## Dennis Jackson - Hydrologist

Re: DEIR for Rodgers/Upper Range Vineyard Project Conversion #02454-ECPA

**Figure 1.** The USGS Lake Hennessey Tributary stream gage is almost adjacent to the Rodgers Upper Range project. The watershed area of the Lake Hennessey Tributary stream gage is 1.04 square miles.

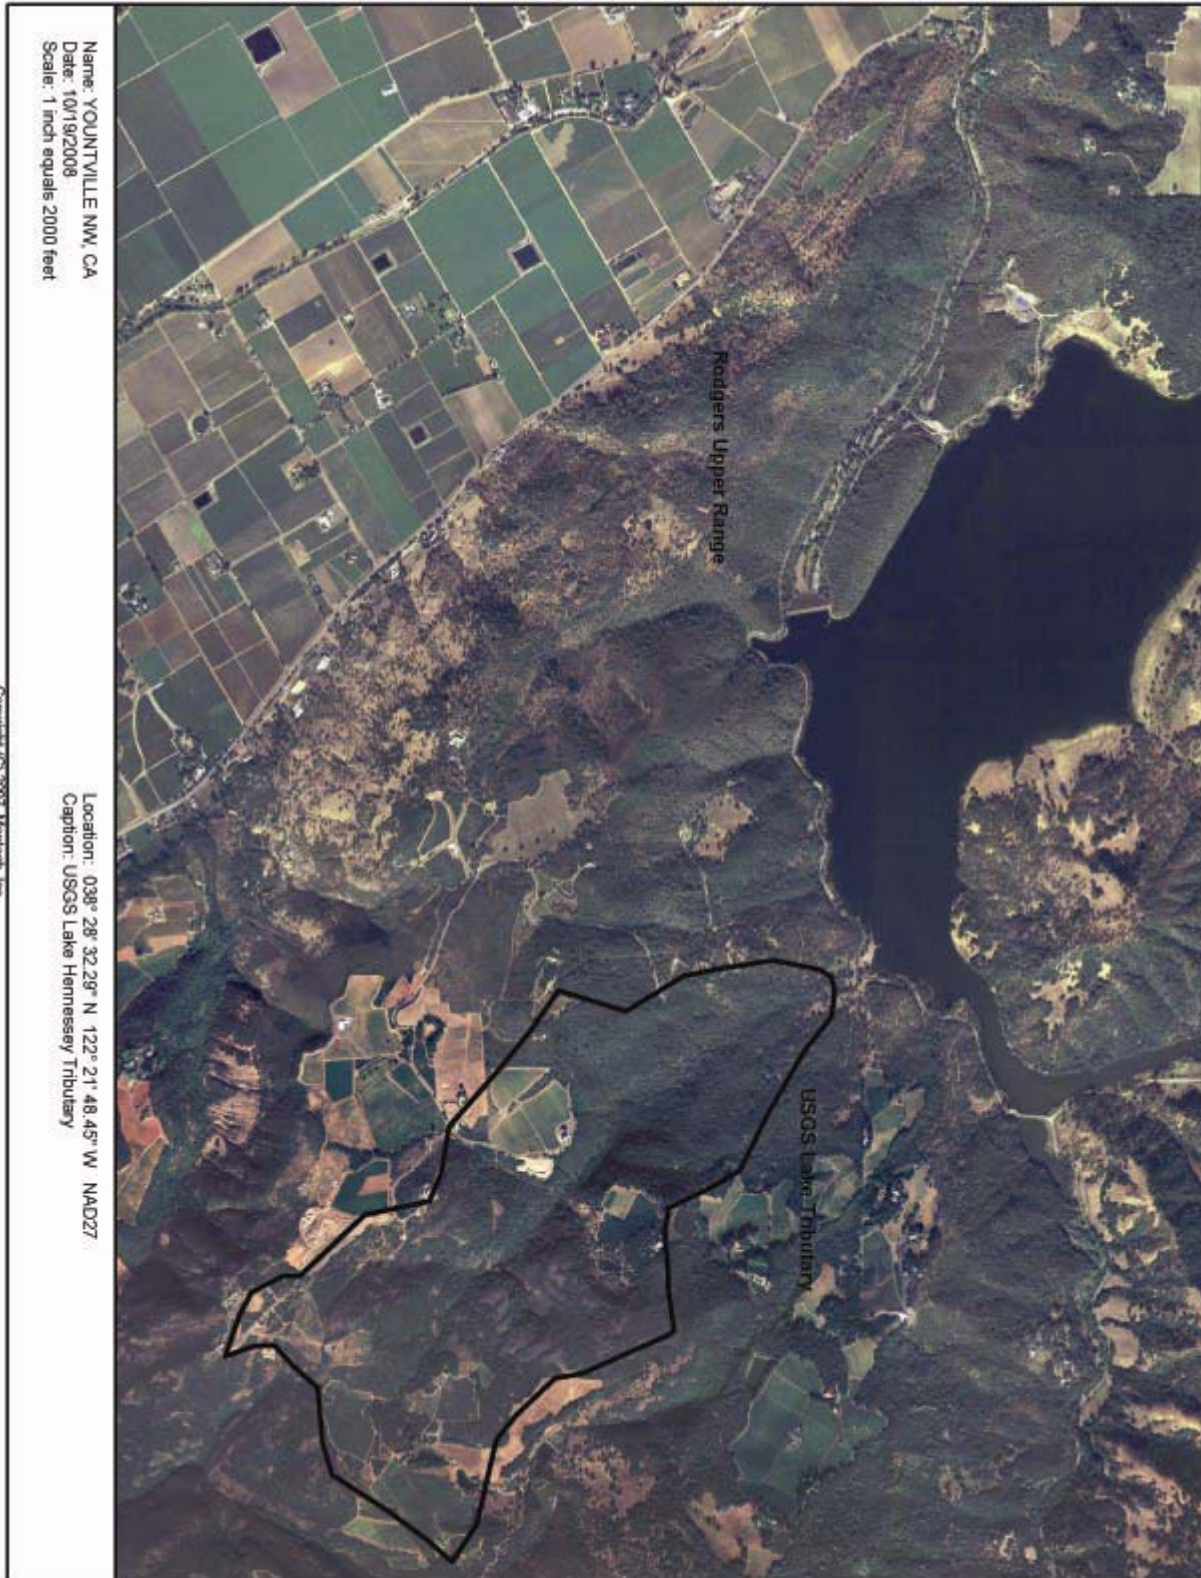
The WIN TR-55 model (Trso, November 2006) does not appear to have been calibrated to local pre-project conditions. The peak flood flows predicted by the WIN TR-55 model for pre-project conditions do not appear to agree with USGS data collected in a nearly adjacent Lake Hennessey Tributary watershed between 1959 and 1973. See Figure 1 for a map showing the location of the USGS Lake Hennessey Tributary gage watershed. Figure 2 shows the soil map from the Upper Range DEIR showing the stream that the USGS measured the flood peaks on. The Lake Hennessey Tributary stream gage (USGS Station Number 11456400) was operated to collect data on the flood response of small watersheds. The watershed area of the Lake Hennessey Tributary stream gage is 1.04 square miles (665 acres). The soils, land use, vegetation, and topography of the watershed of the Lake Hennessey Tributary stream gage are similar to those of Rodgers Upper Range, especially the Lake Hennessey Gulch sub-basin.

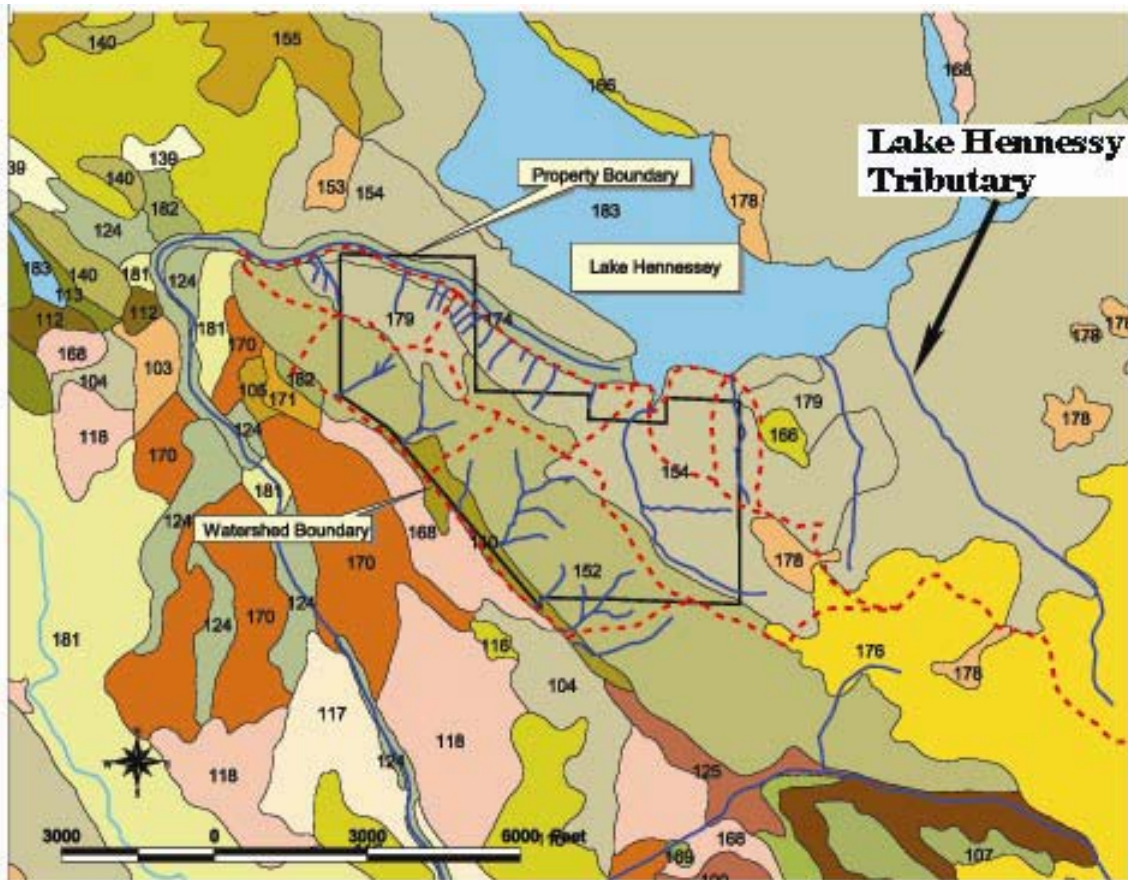
Figure 6 shows the soil map (Figure 3-8 of HIS' Draft Hydrologic Evaluation) with the location of the USGS Lake Hennessey Tributary stream gage. The soil types mapping symbol is a three-digit number.

Figure 3. The estimated 2-year peak storm discharge for the Rodgers Upper Range watersheds do not agree with the 2-year storm discharge measured at USGS stream gages in the Napa River watershed.

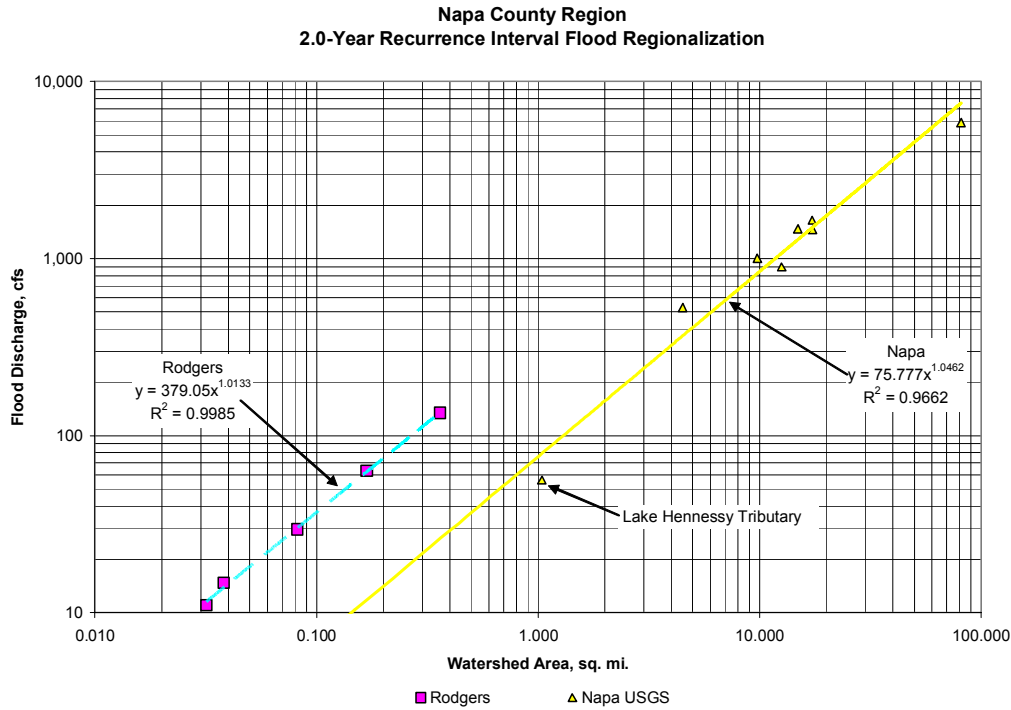
The peak storm discharges predicted by the WIN TR-55 model do not appear to agree with regional peak discharge data from other USGS stations in the Napa River watershed. Table 2 shows data about the location and length of record for the USGS gaging stations used to construct the regional peak discharge graphs shown in Figures 3 and 4. Table 3 shows watershed area and peak storm discharges for the same return period storms used by Trso (November 2006). Figure 3 shows the 2-year peak storm discharge for the Rodgers Upper Range watersheds and for the USGS stream gages versus the watershed area. Figure 4 shows the similar data for the 10-year storm.

In both Figure 3 and 4 the peak flood discharges predicted by the WIN TR-55 model plot higher than the data for the USGS stream gages indicating that the WIN TR-55 model predicts a greater storm peak discharge for a given watershed area than the storm discharges measured by the USGS. It is important to note that the Lake Hennessey Tributary gaging station discharges plot below the regression line for the USGS stations in the Napa River, indicating that the storm runoff from that station is lower than would be expected based on the other USGS Napa River stations.

The pre-project WIN TR-55 storm discharge model does not appear to have been adequately calibrated since it greatly overestimates the storm discharge relative to the regional USGS data, for all flood frequencies. Table 1 compares the Lake Hennessey Tributary storm discharges to the storm discharges for the Upper Range sub-basins. The predicted storm discharges for both the Rodgers Southeast Gulch and the Lake Hennessey Gulch are greater than the storm discharges measured by the USGS even though the watershed upstream of the USGS stream gage (665.6 acres) is much larger than either the Rodgers Southeast Gulch (107.8 acres) or the Lake Hennessey Gulch (231.2 acres)

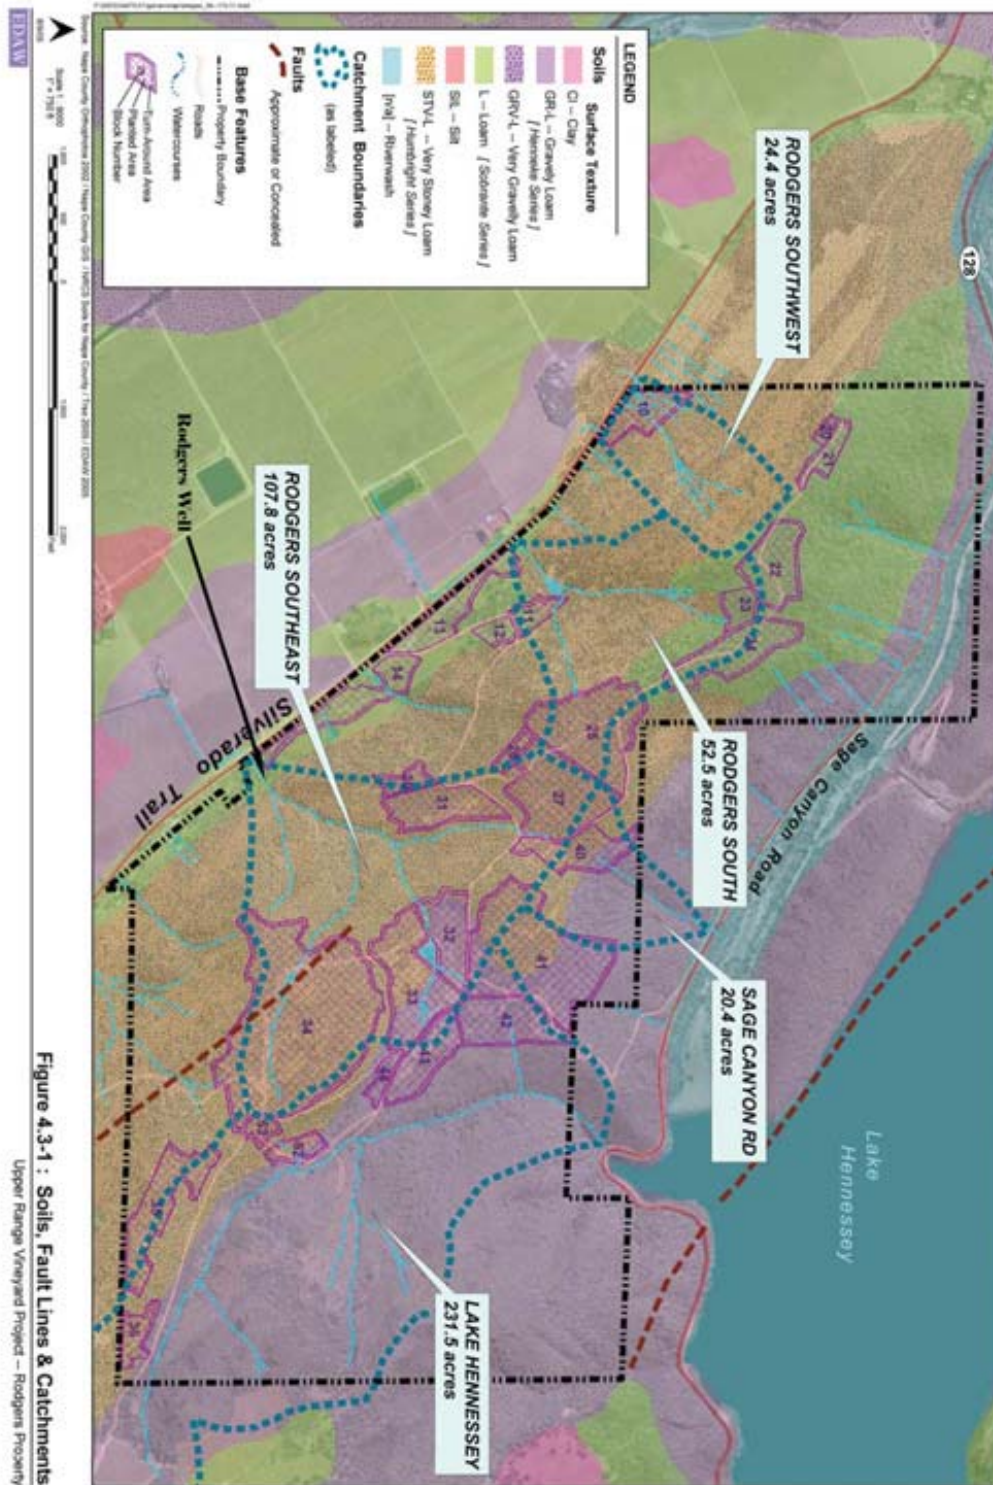
The “groundwater body in question” is the groundwater body that the project production well is drawing water from. Figure 5 shows DEIR Figure 4.3-1, Soils, Fault Lines and Catchments. I have added the location of the project well from the Draft Hydrologic Evaluation (HSI, 2005) Figure 5-1. Figure 5 shows that the project well is in the Rodgers Southeast Gulch which drains an area of 107.8 acres. Only precipitation that falls on the Rodgers Southeast Gulch sub-basin is expected to recharge the well. The DEIR has not presented any information that demonstrates otherwise.

The estimated groundwater recharge is 20.45% of the mean annual precipitation. Groundwater recharge on the hillslopes in the Rodgers Upper Range project area is expected to only a fraction of the estimated 5.4 inches. Figure 5 shows that the runoff from both the Rodgers South Gulch and Rodgers Southeast Gulch soak into the valley floor to the west of Silverado Trail which is off the project property and upslope of the project well. The groundwater recharge estimated by the DEIR does not represent the level

The Draft Hydrologic Evaluation (HIS, 2005) and the DEIR have not adequately defined the groundwater recharge to the project well. A significant portion of the Rodgers Upper Range property drains towards Lake Hennessey (HSI's Zone 1) and Conn Creek just downstream of Conn Dam (HSI's Zone 2). It is highly unlikely that any precipitation that falls on Zone 1 or Zone 2 would be able to provide recharge to the project well. Solid geologic evidence needs to be presented that definitively shows where the recharge to the project well comes from. Until such evidence is presented it is reasonable to assume that the groundwater recharge that supplies the project well comes from the Rodgers Southeast Gulch sub-basin with an area of 107.8 acres. Assuming that the groundwater recharge to the Rodgers Southeast Gulch watershed is 10% of the mean annual rainfall and assuming that the actual mean annual rainfall for the project area is 26.4 inches we get a recharge of 2.64 inches (= 10% x 26.4") or 0.22 feet. Thus the total recharge from the Rodgers Southeast Gulch sub-basin is 0.22 feet x 107.8 acres = 23.7 acre-feet per year. This is far less than the estimated project water demand of 131 acre-feet per year (page 2-5 of HIS, 2005).

This indicates that the water production rate from the well (131 acre-feet) is over five times the estimated recharge rate from the Rodgers Southeast Gulch sub-basin.
